Addendum 3
EN-164-21: Engineering Building, Renovations to EN-2078

- .2 The Date of the Addendum is Monday, January 19, 2026

**EN-164-21: Engineering Building
Renovations to EN-2078**

Addendum 2
EN-164-21: Engineering Building, Renovations to EN-2078

DOOR PLAN,
SCHEDULE
&
ELEVATIONS

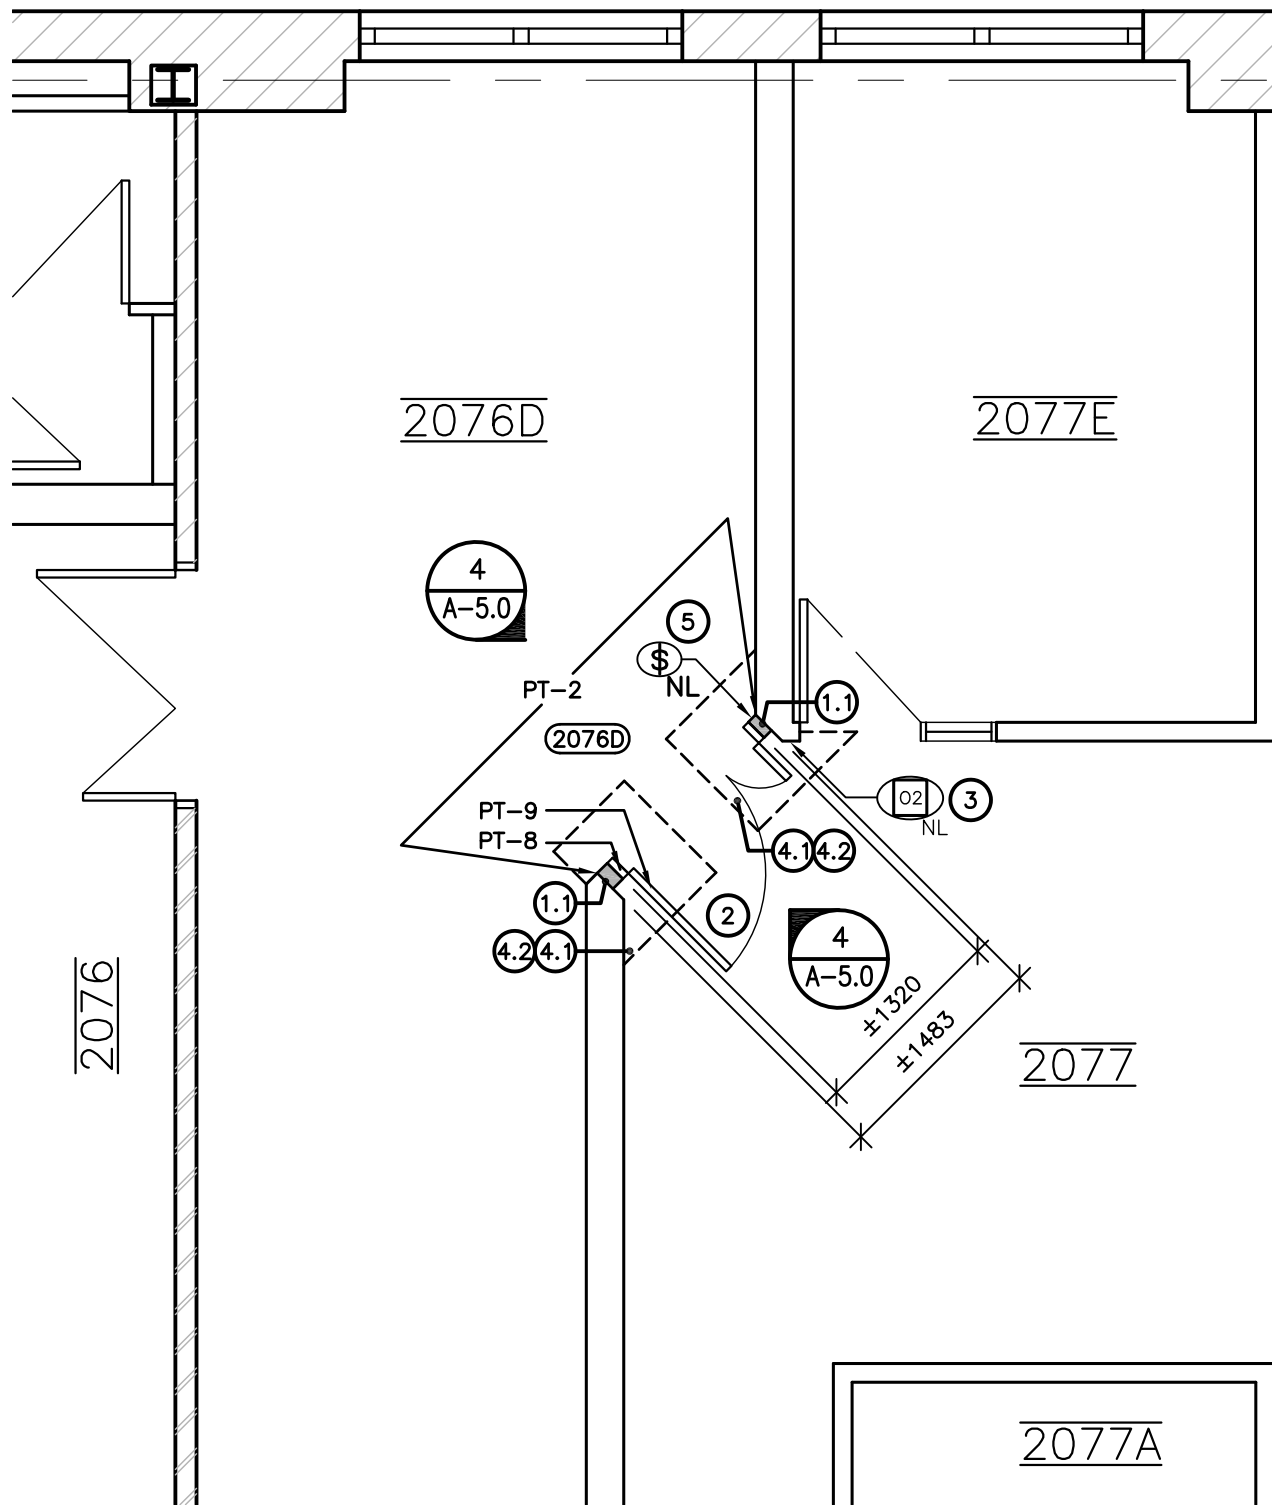
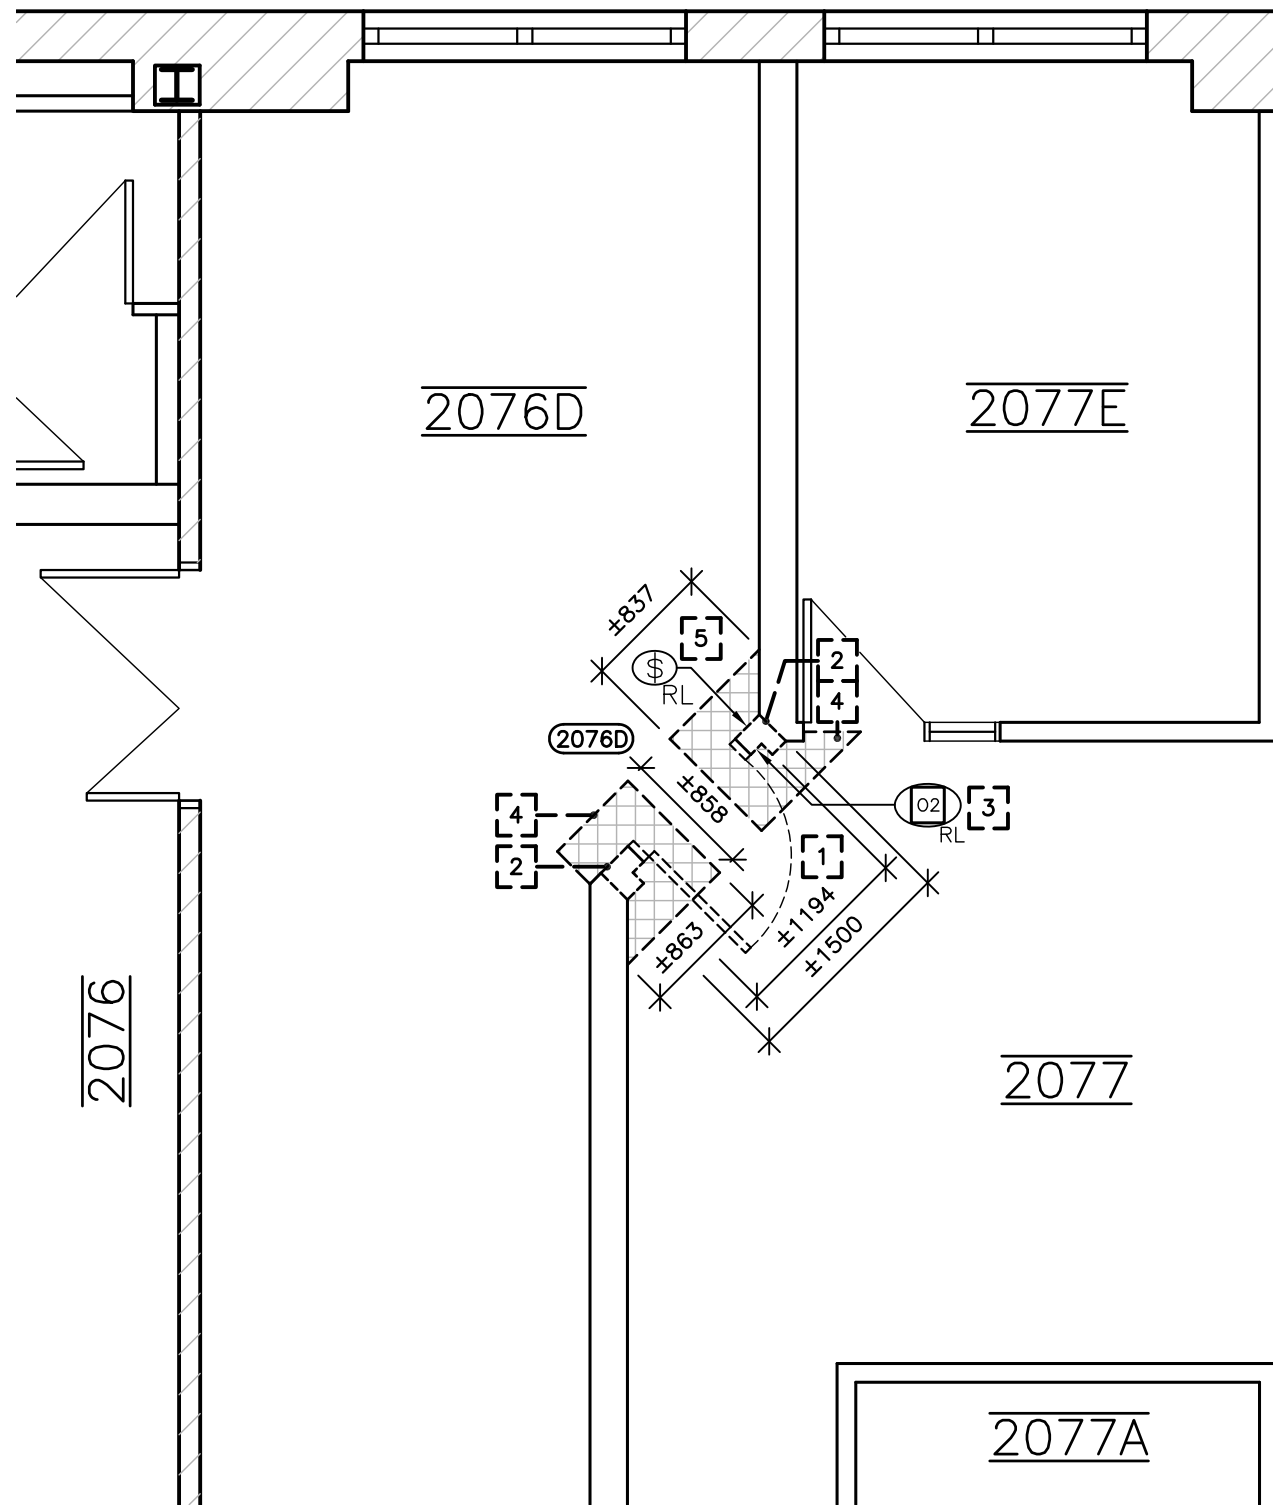
5. Add the following drawing to the architectural drawing set as noted below:

1. A-5.0 – Door Plan, Schedule, and Elevation
